RE: Cedar Apartments
Grading and Drainage Plan
Engineer's Stamp Date: 10/15/19
Hydrology File: K15D062

Based upon the information provided in your submittal received 10/24/2019, the Grading & Drainage Plan **is not** approved for Building Permit. The following comments need to be addressed for approval of the above referenced project:

GRADING AND DRAINAGE PLAN

CEDAR APARTMENTS
541, 543, & 545 CEDAR STREET S.E.
ALBUQUERQUE, NEW MEXICO

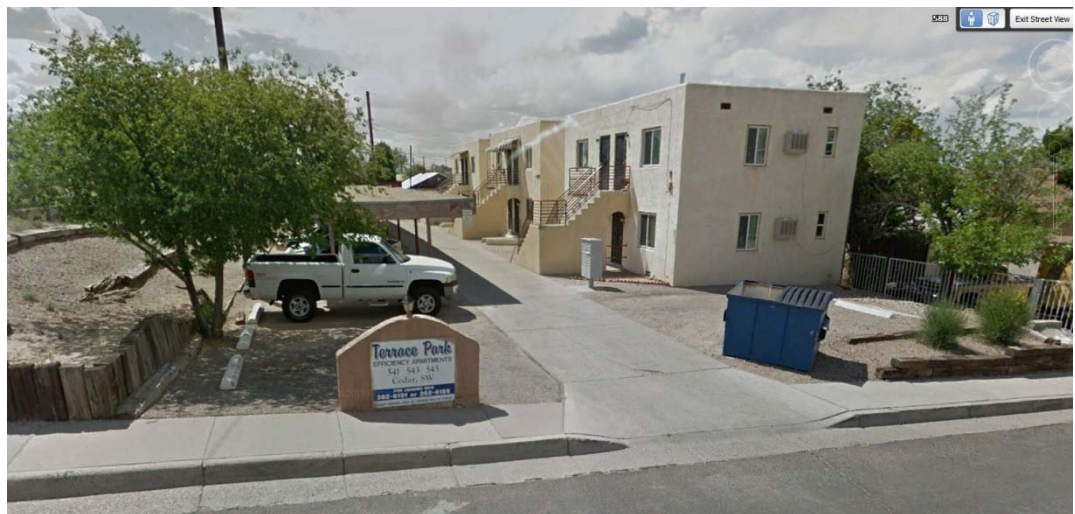
6. Payment in Lieu (Amount = $359.5 \text{ CF} \times \$8/\text{CF} = \$2,876.00$) of onsite management of the SWQV must be made. Take three copies of the attached treasury deposit slip to the Treasury and then include one copy of the paid deposit slip when resubmitting.
7. It appears that there are several items that were built within the Cedar Street R.O.W. (wood walls, concrete slab, sign, and made ramp in the gutter. Please remove these items and relocate them on the project's property. See photos below.

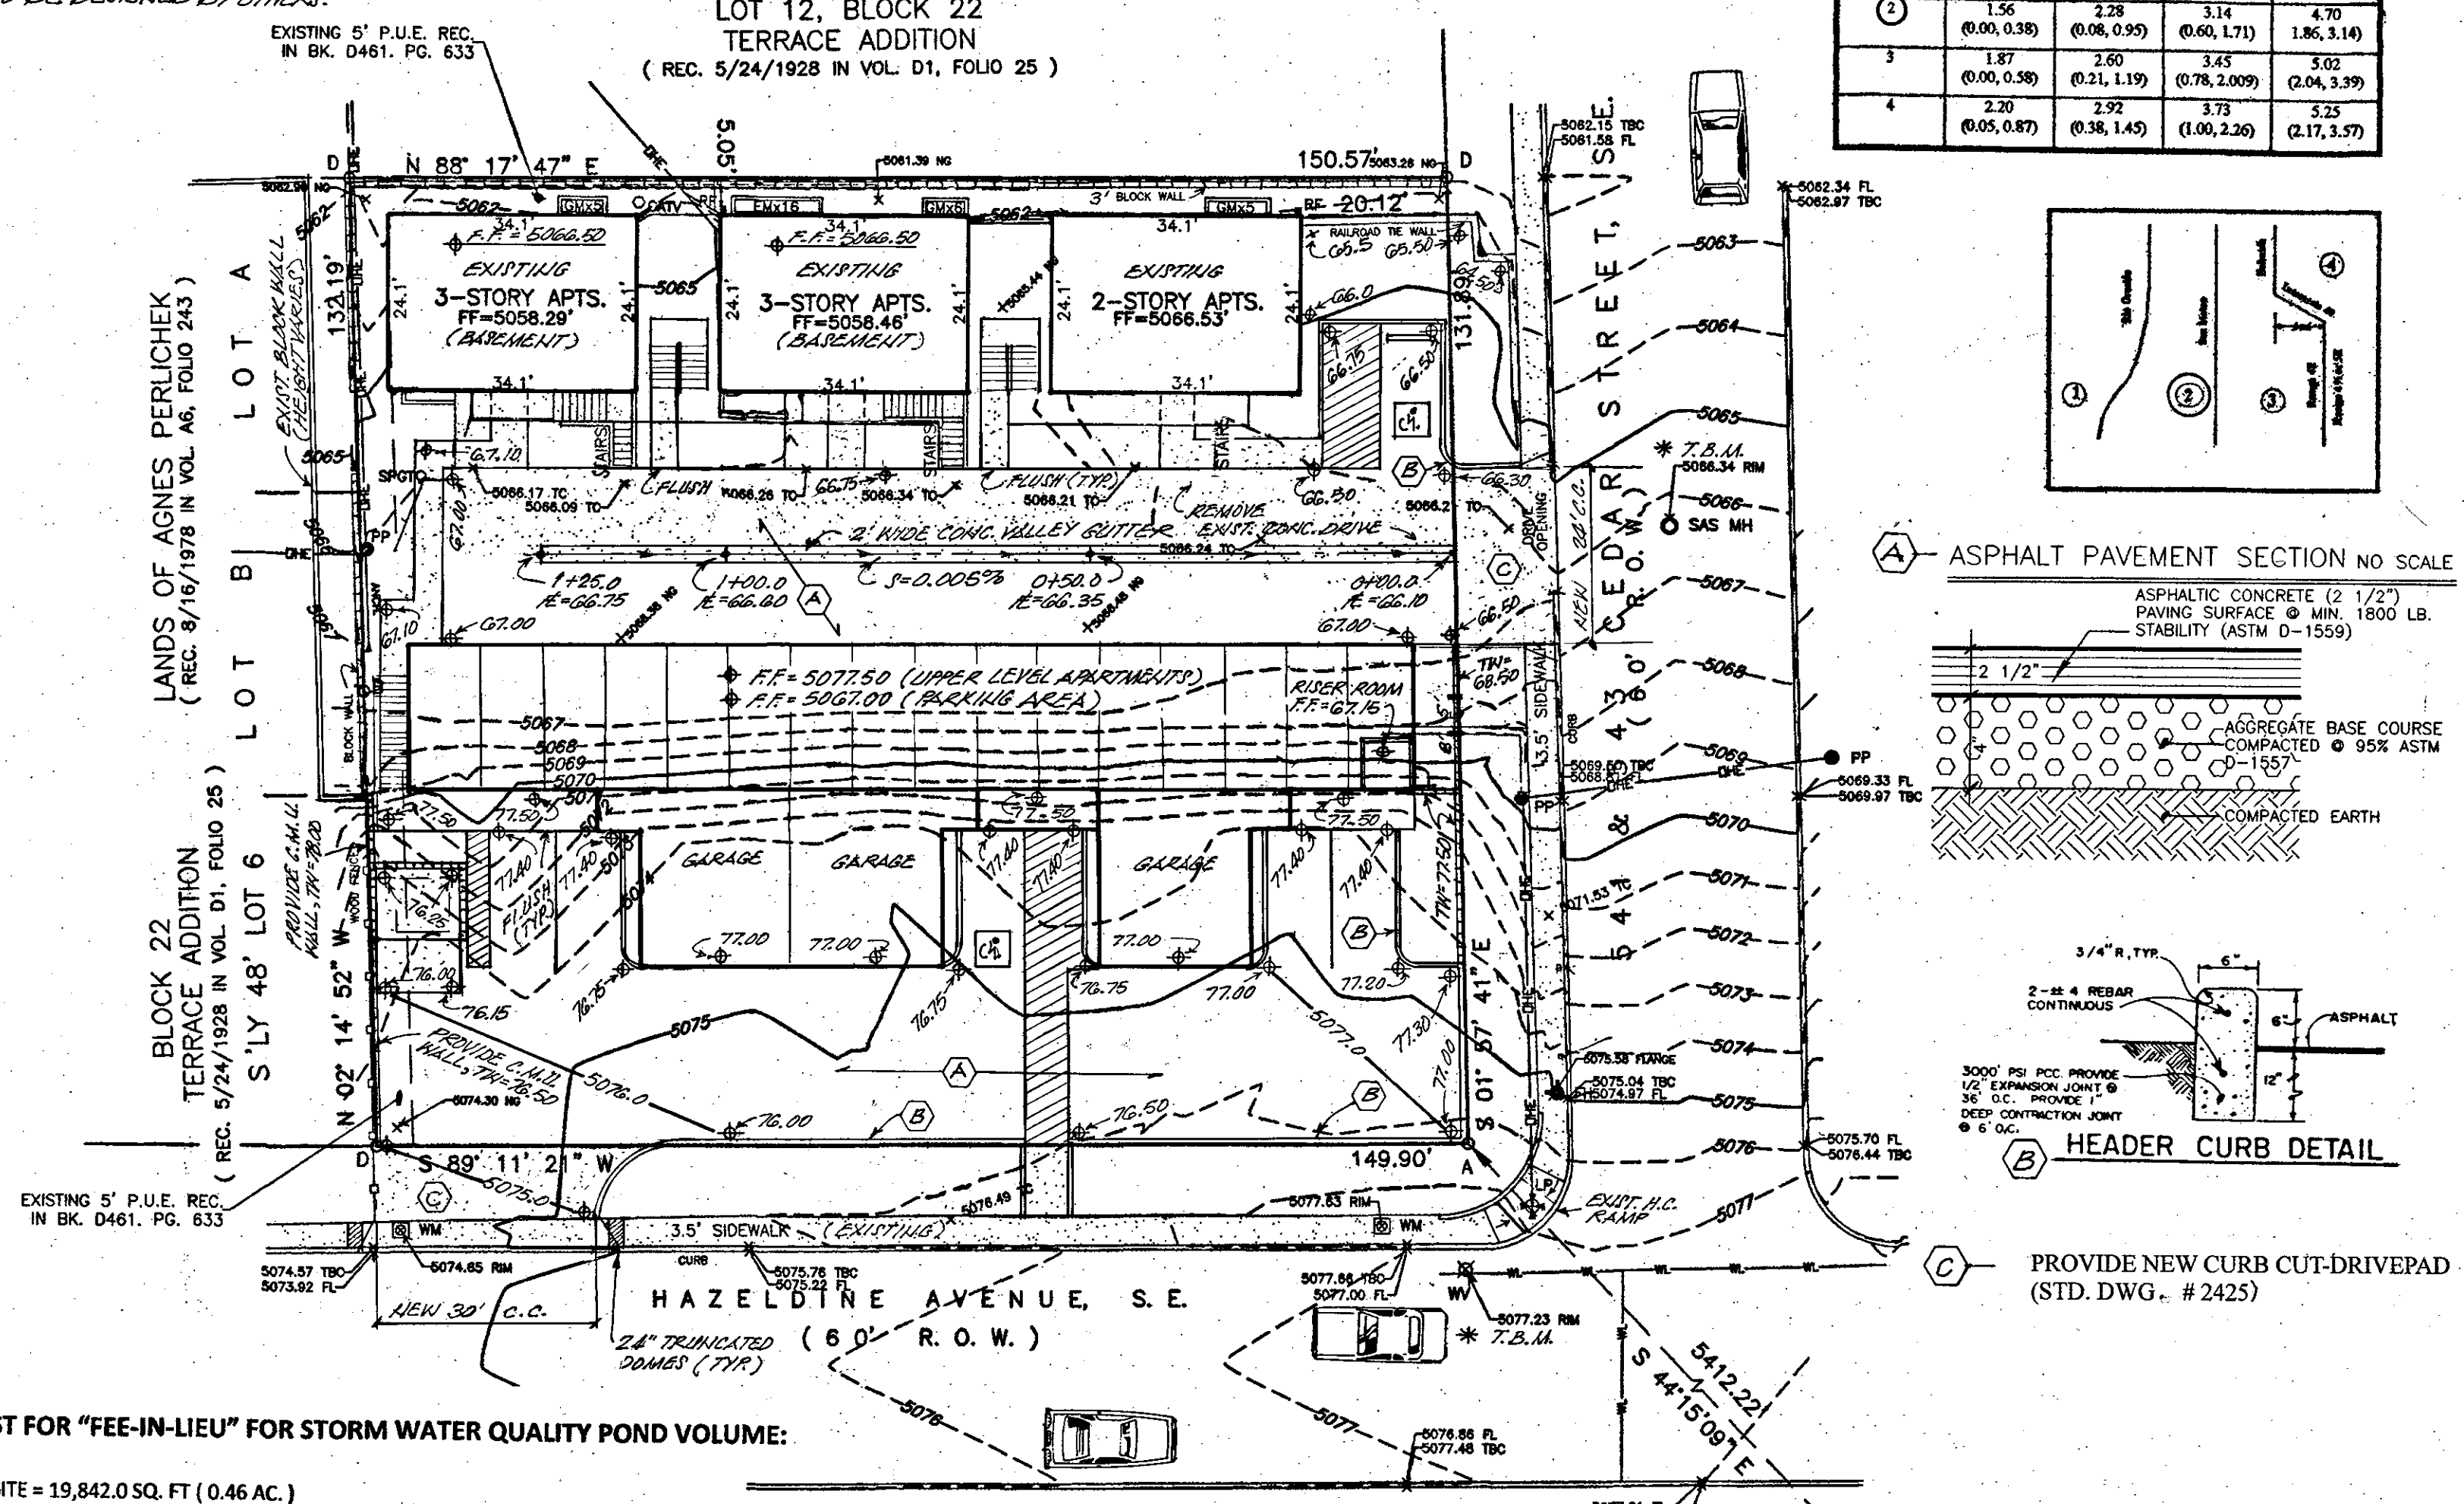
2. Please shade back all existing items. It is very difficult to tell what is existing and what is being proposed.

3. There are no drainage facilities being constructed within the R.O.W. so please remove the SO-19 notes.
4. It appears that there are proposed walls along the property lines. Please provide sections through all external boundaries showing proposed retaining walls, garden walls, property/ROW lines, existing and proposed grades. In accordance with DPM Ch.22, section 5 part B, grading and wall construction near the property line may not endanger adjacent property or constrain its use.
5. If the proposed retaining wall will create such an encroachment, written agreement from both landowners must be provided for such work. Written permission must include: signature of the property owner or owners representative, statement that undersigned is the owner or authorized representative, permission to construct the encroachment with a brief description of the encroachment.

8. Talking to the Transportation Section, the Grading Plan does not match the approved TCL. Please coordinate to ensure that the plans match.
9. Also please check with the Transportation Section, the drive on Hazeldine Ave needs to be shifted to the east so that the wing of the drive is within the perpendicular line from the property corner. Also the existing light pole needs to be relocated out of the existing ADA ramp at the corner of Hazeldine & Cedar. Also the tree in the R.O.W. needs to be removed as well. See attached photo.
